*This presentation addresses some comments that were submitted as individual comment, per the rule one comment per issue, however they are related since they touch the same STATES and exit conditions and their solution need to be integrated for completeness and easy and clear instructions for the editor if these comments will be accepted.*

### [Comment i-250 \(Page 136 Line 20\).](#)

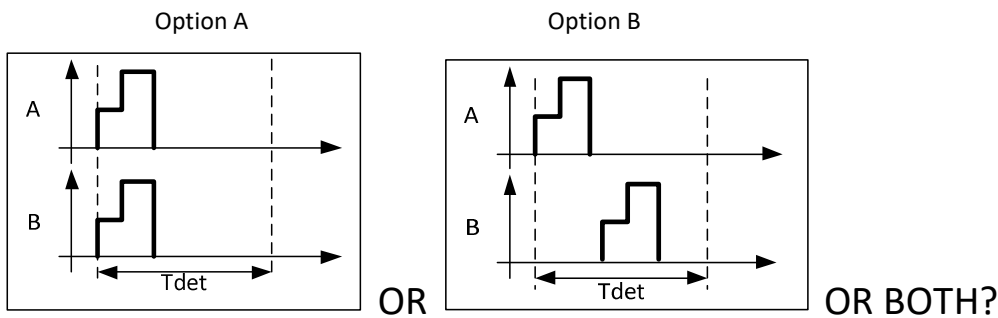
**Comment i-254 (Page 136 Line 11).**

**The exit from IDLE\_SEC to START\_DETECT\_SEC.**

In the exit from IDLE\_SEC to START\_DETECT\_SEC we have the following condition:

$$(!pwr\_app\_sec * pwr\_app\_pri) + ((CC\_DET\_SEQ=3) * option\_probe\_alt\_sec * !det\_start\_pri * !det\_once\_sec.$$

"(!pwr\_app\_sec \* pwr\_app\_pri) + ((CC\_DET\_SEQ=3) \* option\_probe\_alt\_sec \* !det\_start\_pri \* !det\_once\_sec)"

"(!pwr\_app\_sec \* pwr\_app\_pri) + ((CC\_DET\_SEQ=3) \* option\_probe\_alt\_sec \* !det\_start\_pri \* !det\_once\_sec) + (class\_4PID\_mult\_events\_sec\*(CC\_DET\_SEQ=3) \* !det\_once\_sec \* det\_once\_pri )

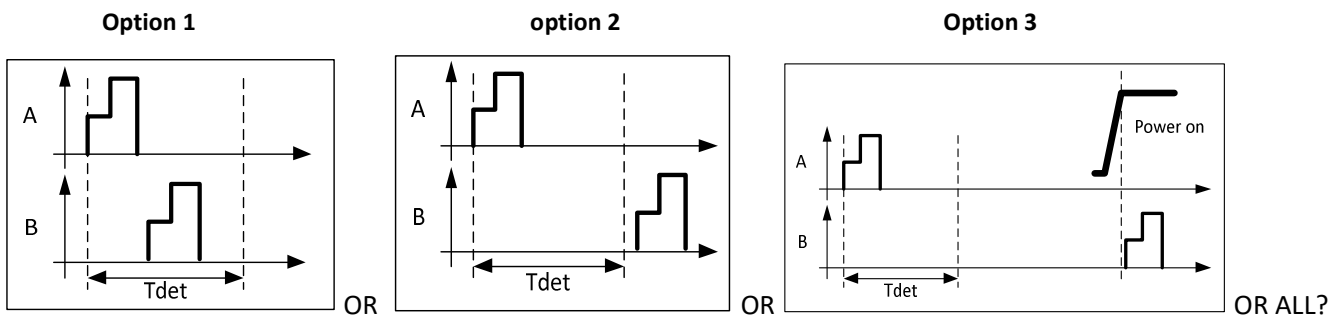
In "parallel detection" the intent was to do simultaneous detection on both pairsets in order to check if detection signature is corrupted when single-signature PD is connected. Now, in D3.0, it is not clear if it is "simultaneous detection on both pairsets" or detecting both alternative in one detection cycle (Tdet) or both.

**We need to define which definition to adopt?**

In staggered detection, it should be any non-overlapping detections, with no limits on tdet2ted. As a result, staggered detection could be any of the following:

The last two options must be covered (2 and 3). The first option (1) depends on what is the definition for "parallel" (See above).

Staggered detection range may occur with starting the secondary detection after doing the primary detection (option 1 and 2) up to doing the secondary detection when the primary is on (option 3). This covers the full range of possibilities for staggered detection. Option 1 and 2 in CC\_DET\_SEQ=3 is normally used when class\_4PID\_mult\_events\_sec=TRUE. This currently is not covered by the state machine for CC\_DET\_SEQ=3.
